REQUEST

Current Zoning: R-3 (single family residential)
 Proposed Zoning: UR-2(CD) (urban residential, conditional) with five-year vested rights.

Approximately 3.49 acres located on the east side of Park Road, north of Sharon Road.
 (Council District 6 - Bokhari)

The petition proposes redevelopment of four parcels containing three single family homes with a 20-unit, single family attached development along Park Road north of Sharon Road.

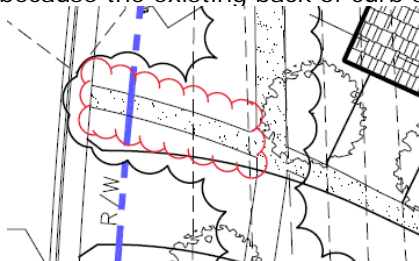
1. Remove the section of internal sidewalk, shown below, that is parallel to the northern most driveway between the proposed sidewalk along Park Road and the existing back of curb sidewalk because the existing back of curb sidewalk should be removed. Addressed
